ADDENDUM NO. 1

| Project: | First United Methodist Port St Joe Selective Demolition | | |
| Date: | August 6, 2021 | Bid Opening Date: August 19, 2021; 2:00 pm | |

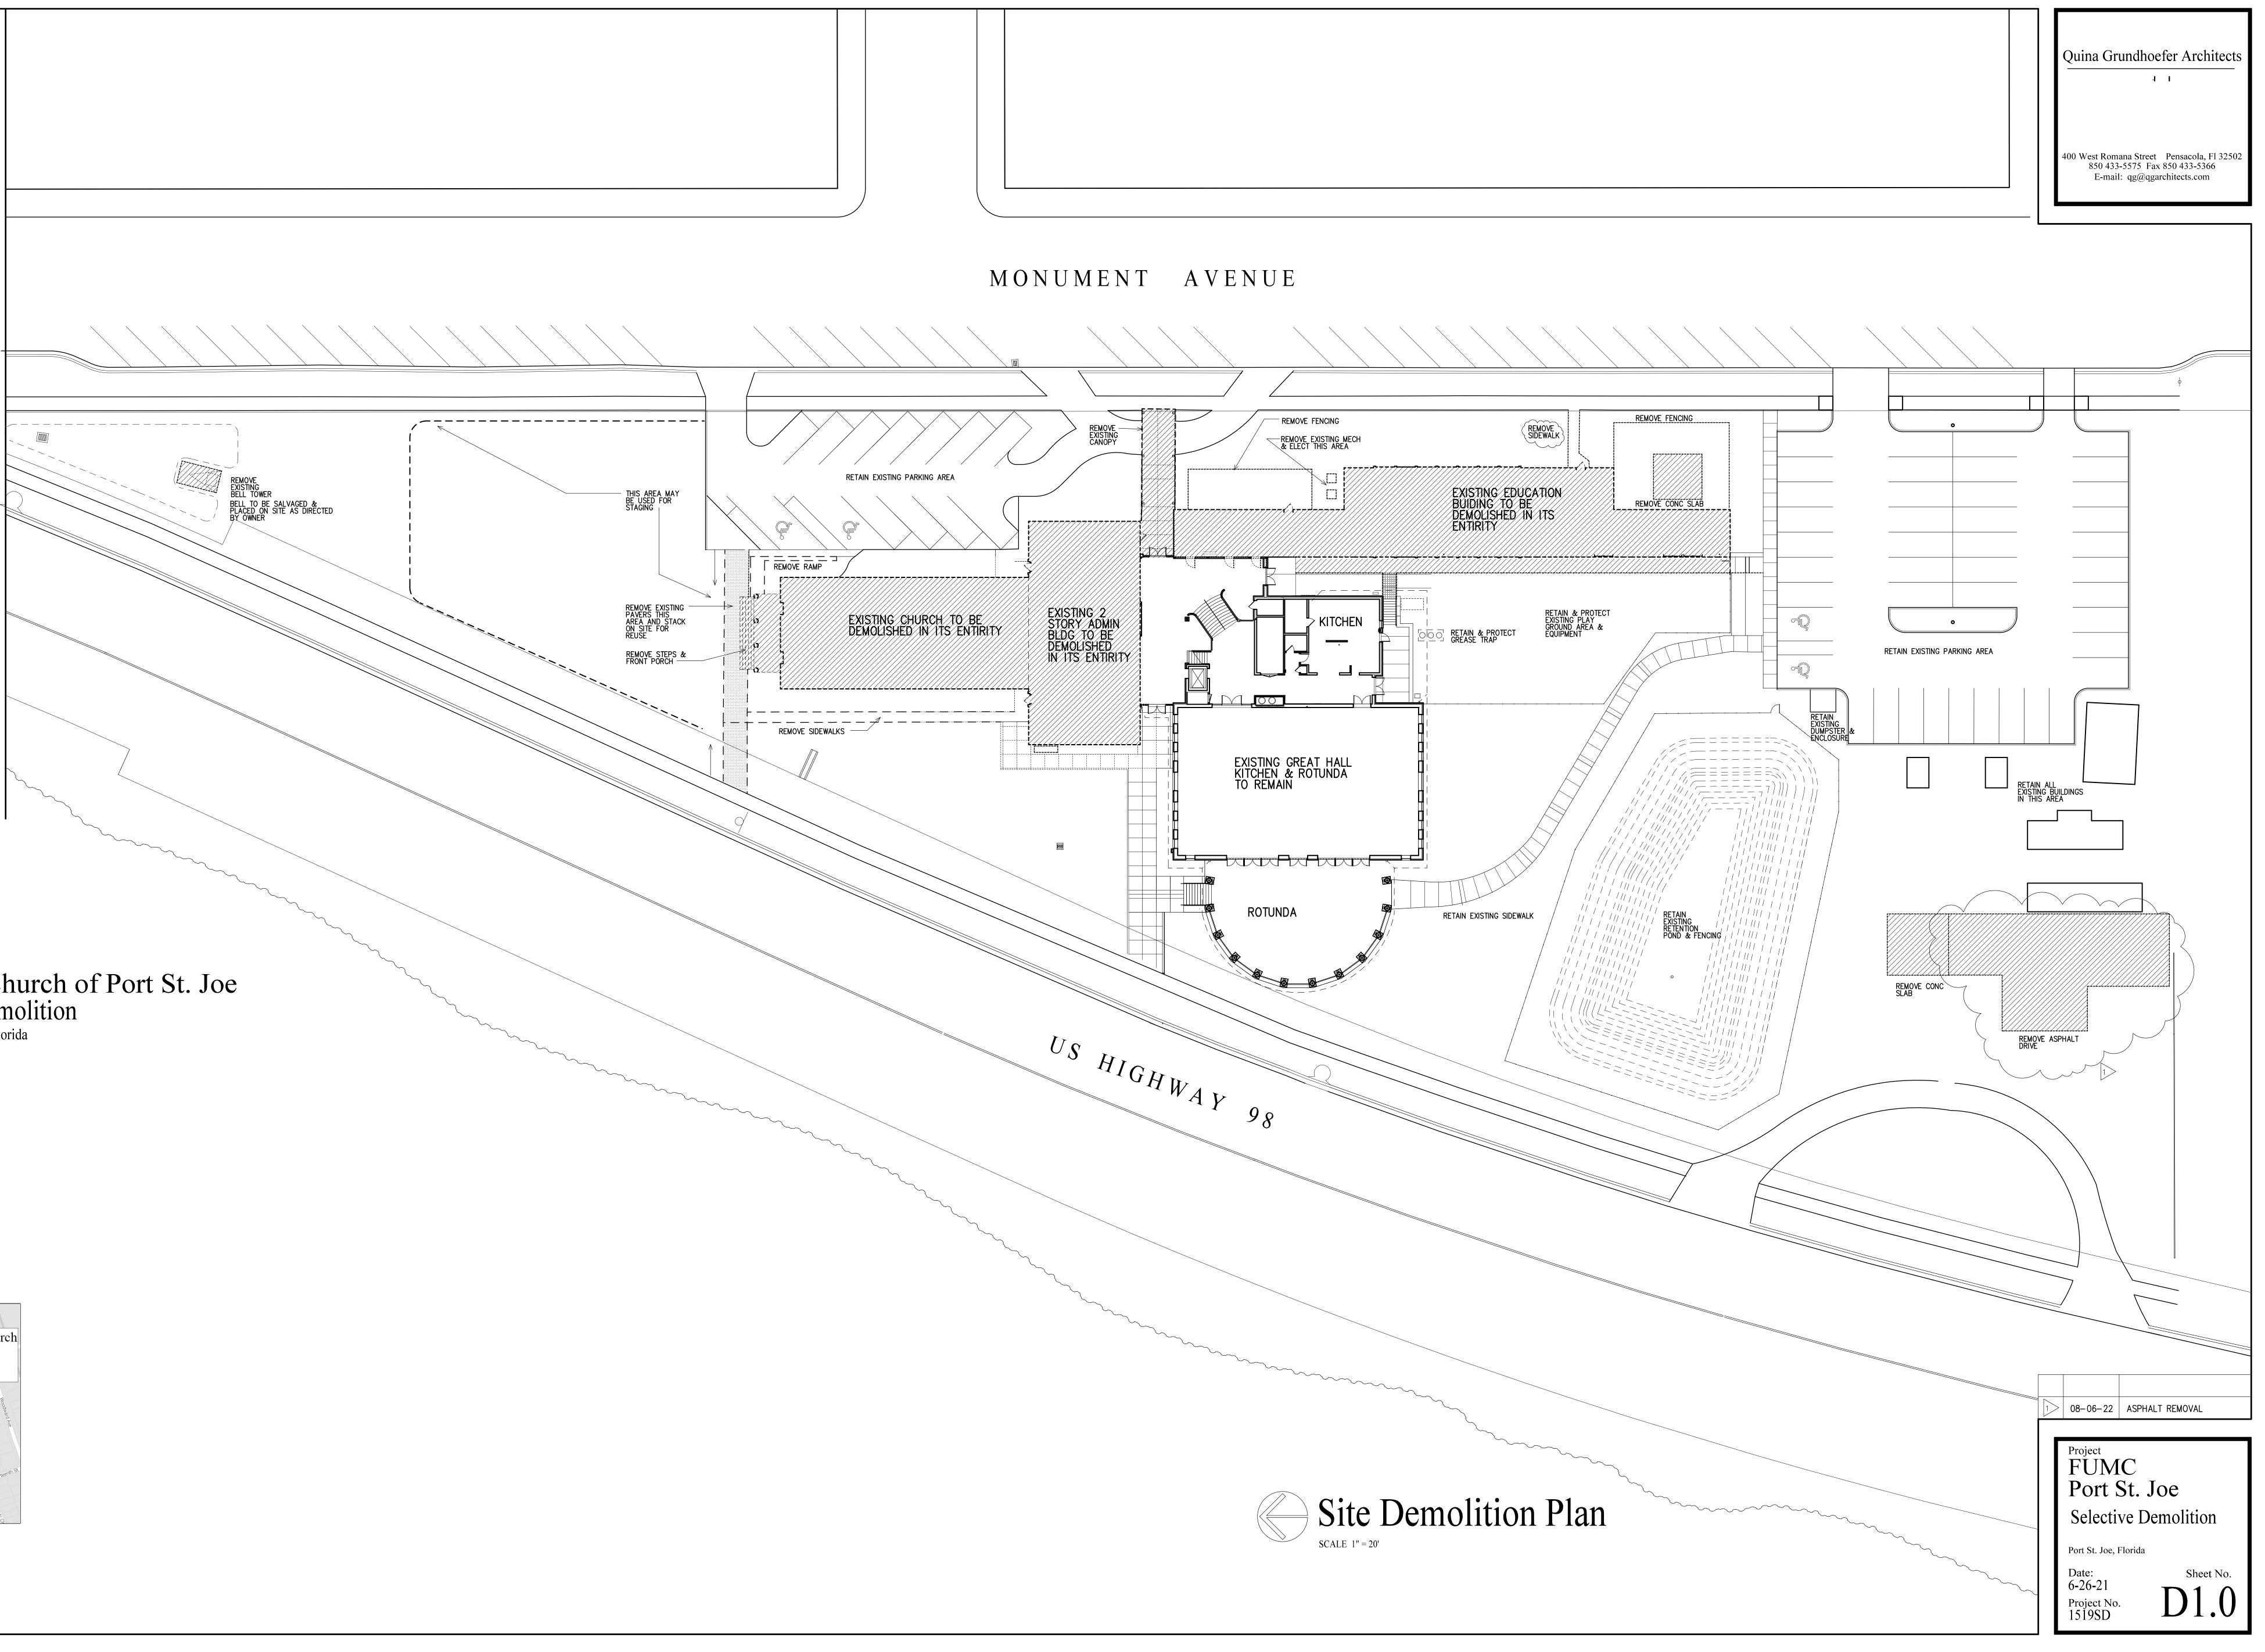
- 1. **Refer to Sheet D1.0:** Additional area of asphalt driveway and sidewalks were identified to be removed as Revision 1.
- 2. **Refer to NEW Sheet D1.3:** This sheet was added to clarify the post demolition floor plan and the temporary walls that are to be NOW included in the demolition base bid. Contractor is to provide price for the temporary walls as described on this sheet in the quantities estimated.
